Application No.: 10/669,380
Art Unit : 3653

Docket No. 4468.02
Confirmation No. 3369

AMENDMENTS TO THE DRAWINGS

REMARKS

FIG. 1

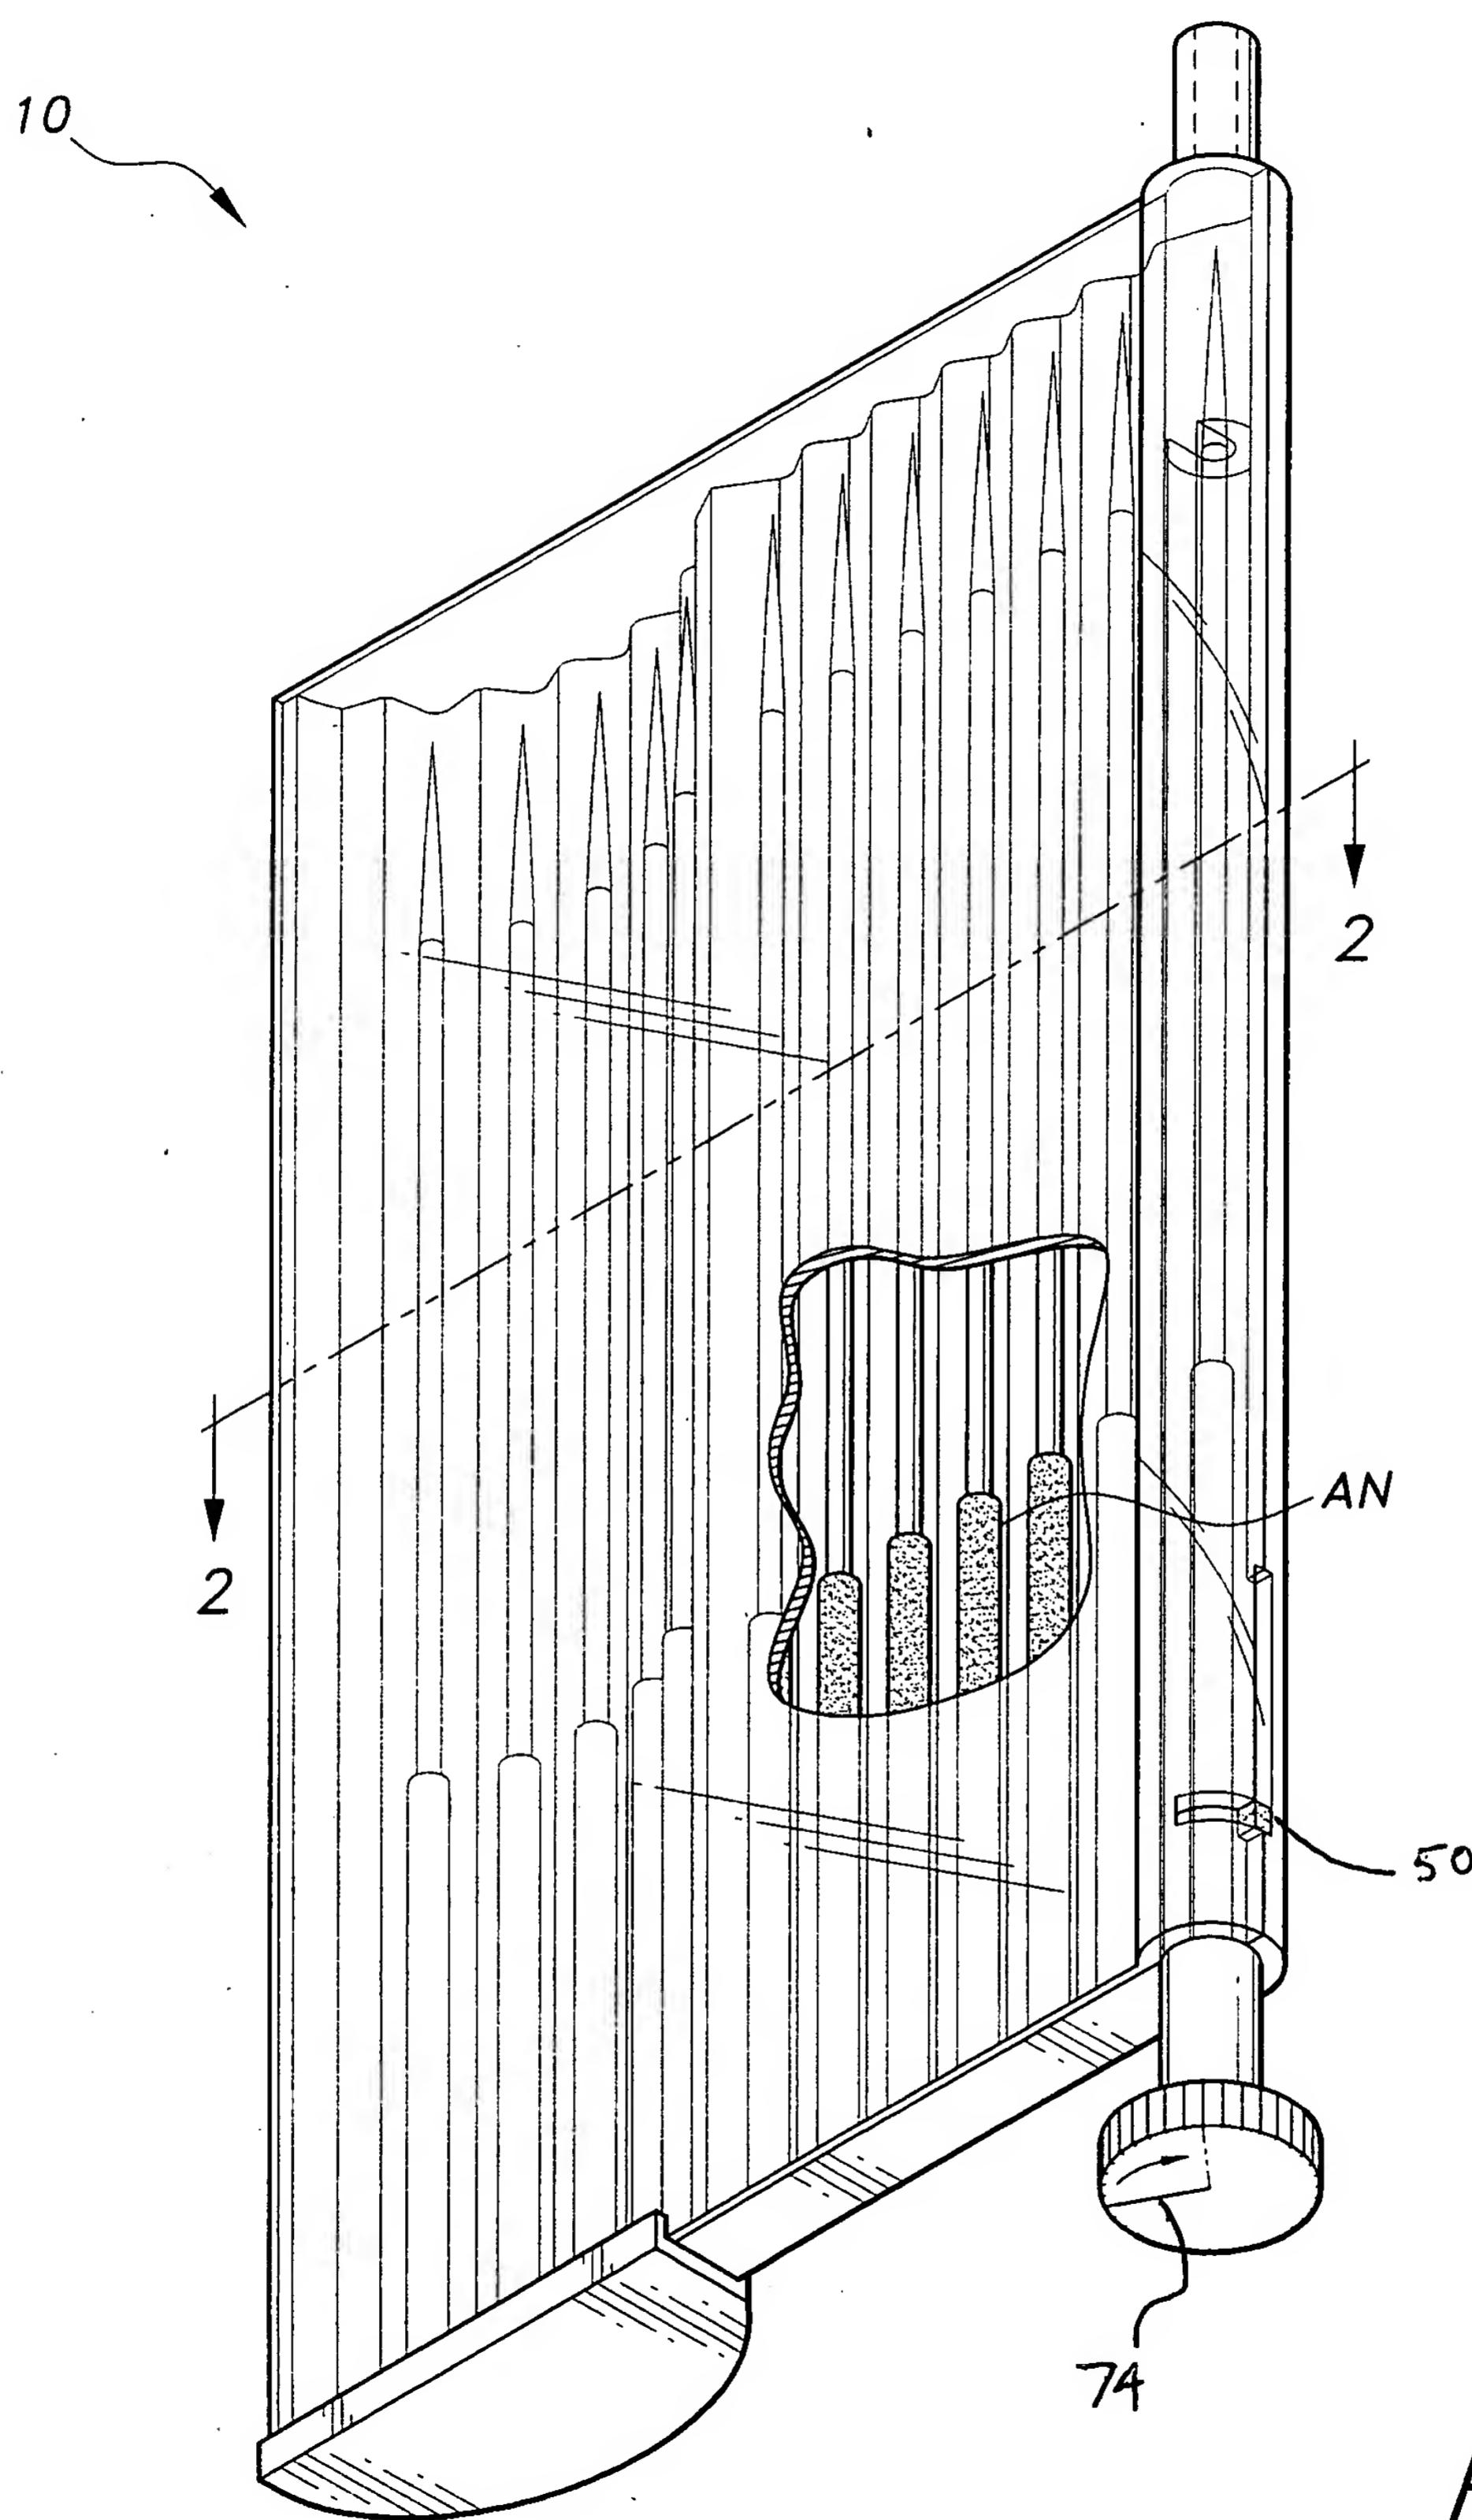
The Examiner objected to the drawings as not showing every claimed feature, specifically the click and hold mechanism and the indicia. The click and hold mechanism has been canceled from the claims, and the indicia has been called out in Figure 1 as reference numeral 74.

The attached replacement sheet and annotated sheet of drawings indicates the replacement of Figure 1.
